West Burton Solar Project

Environmental Statement

Figure 8.18.2: Landscape and Ecology Mitigation and Enhancement Measures West Burton 2 Revision A

PINS reference: EN010132
Document reference: EX1/WB6.4.8.18.2_A
APFP Regulation 5(2)(a)

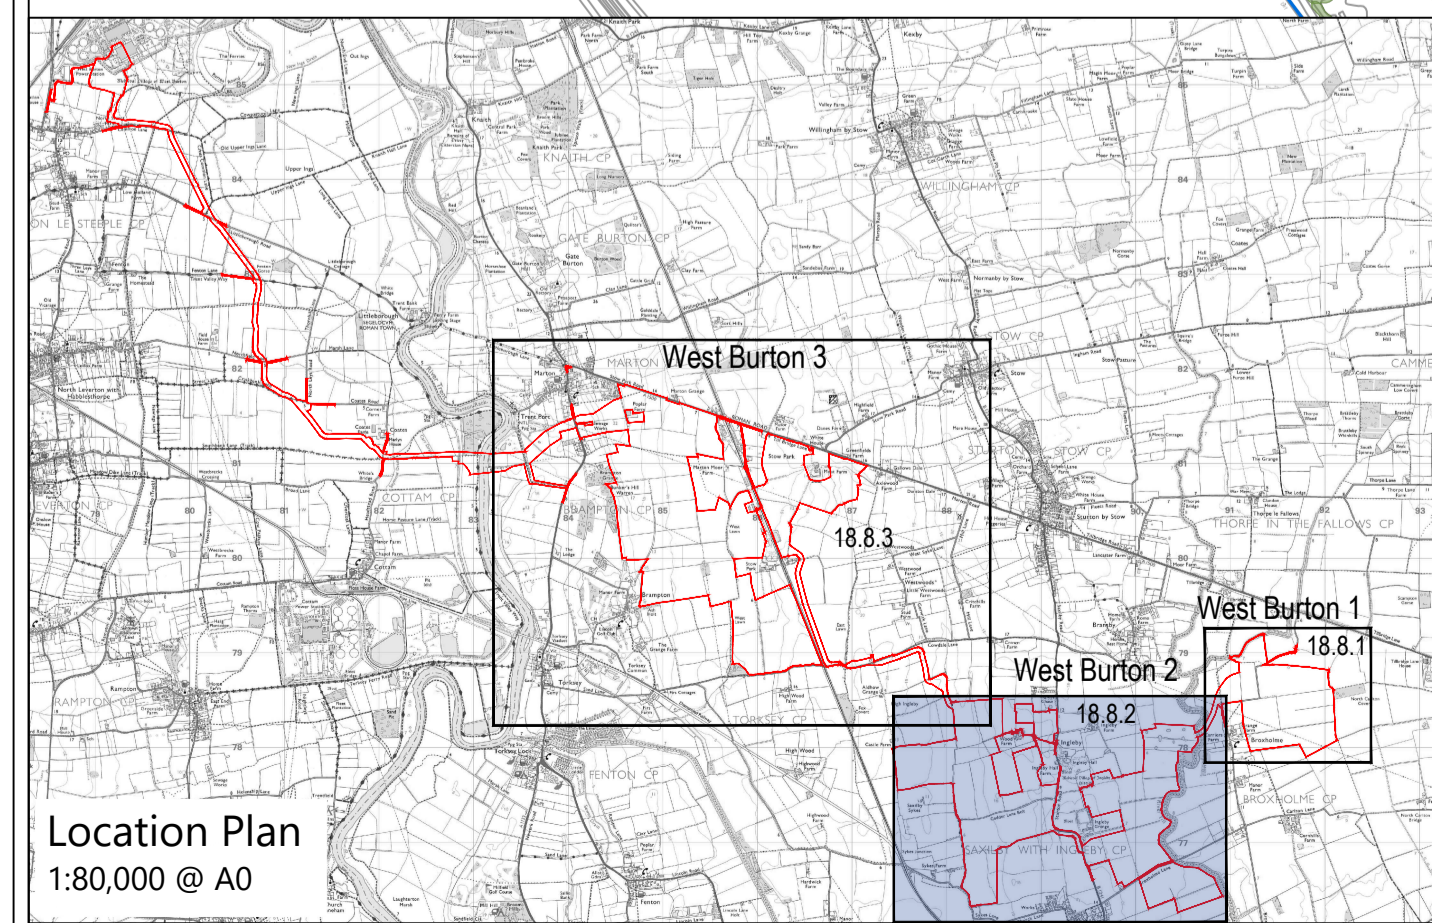
Figure Reference	Page	Description of Changes	Reason for Revision
WB6.4.8.18.2_A	3	<p>Change to spelling of 'enhancement'.</p> <p>Amend the wording of hedgerow removal in the key from 'Existing hedge to be removed' to 'Existing hedge to be removed permanently'.</p> <p>Offset calculations from drains.</p> <p>Changes to hedgerow removal locations.</p> <p>Changes to proposed woodland planting.</p>	<p>To correct a typo.</p> <p>For clarity.</p> <p>For clarity.s</p> <p>For clarity.</p> <p>In response to changes to proposed cable route and tracks</p>
